ATR on Quality Control Check Repot. (Bungalows)

Quality Control Check Repot. Stage: After Plumbing & Electrical (Villas)

1					
Bungalow no.	18	Stage	1	SI. No.	28762
Company	Severe Constitutions Project	Project	Seven Lamo	Phase	100
Prepared by	M. Ica Svidhur	Sign		Date	41 81
Project Manager	Bala mulilling him	Sign	Coll	Date	4 8 186
Previous stage report no.	no,	44498	Report filed and signed by	1 by PM?	Yes No
Additions & alterations sheet date	is sheet date	-t1/30/18	All pages signed by engineer & customer?	gineer & customer?	XX es No
Checked By MD on		MD Sign		For filling	Yes No
Recommendation: Stop further work.	Submit ATR on OC re	mort to OC' (earn proc	and only offer makes 1.1.		
Stop further work. Stop further work. Proceed with furthe	Stop further work. Submit ATR on QC report to QC team. Proceed only after rechcck less Stop further work. Proceed with work after submitting ATR on QC report to QC team. Proceed with further work only after making corrections pointed out in the QC report. Proceed with further work. ATR not required.	port to QC team. Proces reasonable and Process submitting ATR on ing corrections pointed ired.	Stop further work. Submit ATR on QC report to QC te

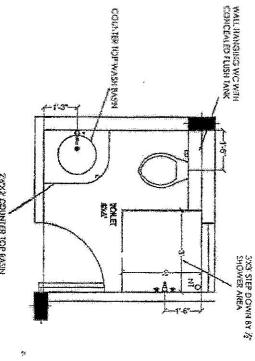
Cooste	The work	D.C. Charle	Remarks: Floori
O Barlo	Coastral Jos the flooring of Tiling	orle as the dispone is	Dr. Charle die to the Vendor Avandituty	& Tiling booth i
	January (S) friend	ligame is long		
	work at a line	~	me make the	Completed before
